# Product Change Notification

**Change Notification #:** 118956-00  
**Change Title:** Intel® Server System M50CYP1UR212, PCN 118956-00, Product Design, Label, Move S5.2 DIP Switch status to OFF and update UKCA logo  
**Date of Publication:** March 15, 2022

Figure 1. Switch S5\_2 before change (ON)

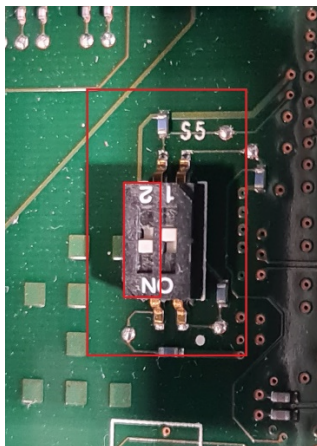
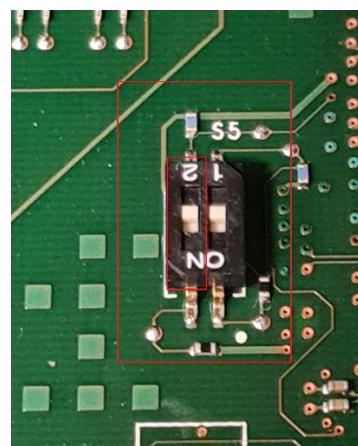
- Move S5\_2 switch from “ON” to “OFF” position on the motherboard to enable functionality of Intel® Trusted Execution Technology (Intel® TXT).

Figure 3. Location of S5 Switch

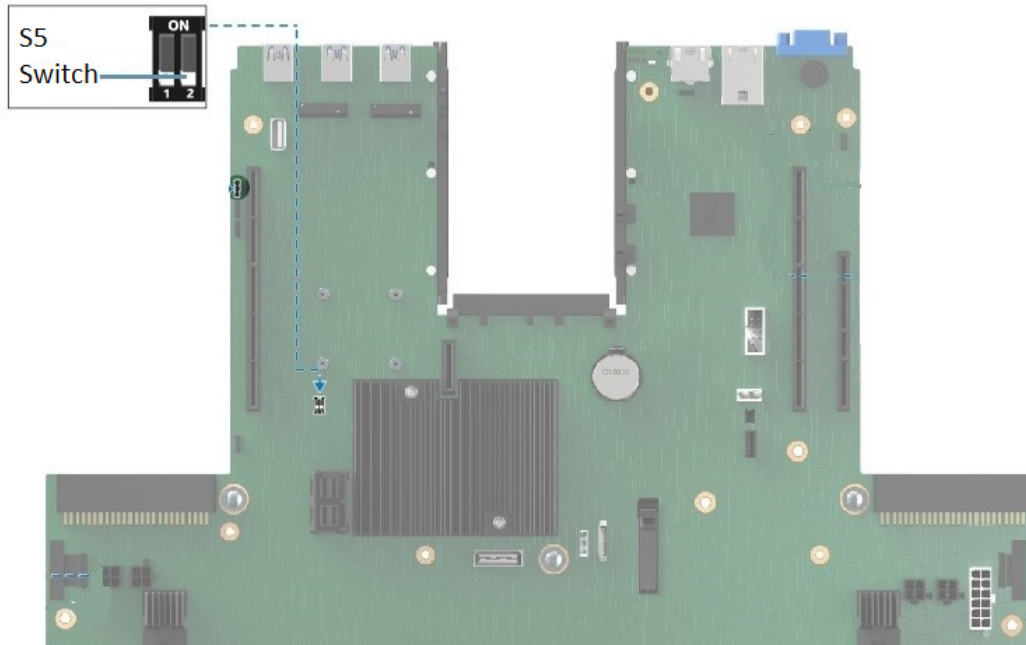
The location of S5 switch can be observed in the picture below:

Figure 7. Packaging box after the change

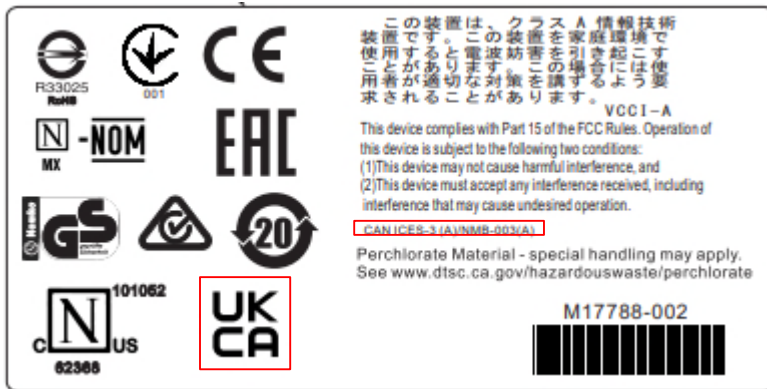
- Adding UKCA logo and updating Canada mark on the chassis and packaging box labels.
